Hydrol. Earth Syst. Sci. Discuss., doi:10.5194/hess-2017-42-AC1, 2017 © Author(s) 2017. CC-BY 3.0 License.

Interactive comment on "Ecohydrological Optimality in Northeast China Transect" *by* Zhentao Cong et al.

Fig. 2.

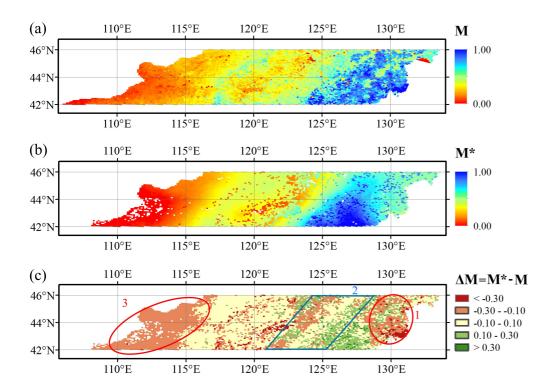
be regarded as 1 when the NDVI is above NDVImax and as 0 if the NDVI is below NDVImin. 12. P4L4: Rn should be in italic. RESPONSE: It is accepted. 13. P4L5: Max and min temperature are not required for Penman (-Monteith). RESPONSE: Yes, Max and min temperature are not required for Penman (-Monteith) in general. Here we used the FAO-Penman-Monteith Equation, where Max and min temperature were used to calculate the actual water vapor pressure. 14. P4L10: ".. He considered THAT climate and vegetation.." RESPONSE: It is accepted. 15. P10L28: Please keep your units consistent. Here Epd has unit [mm/day] while E(Er) is in mm. RESPONSE: All the units of evaporation are mm/day, but Er is the storm surface retention depth of each storm. So the unit of Er is mm. 16. Table 2: how is interception, runoff and evaporation calculated and what is the relation with Equation 6? RESPONSE: Yes, all the components of water balance are estimated based on Equation 6, which had been stated when the Table 2 was referred. 17. Fig 1: unit of annual rainfall is [mm/y] RESPONSE: It is accepted. 18. Fig 3: Add in legend that $\Delta M = M^*-M$. RESPONSE: It is accepted. 19. Fig 5 6: lower right figure is not alligned well. RESPONSE: The aligning problem is caused by the WORD and we had improved it.
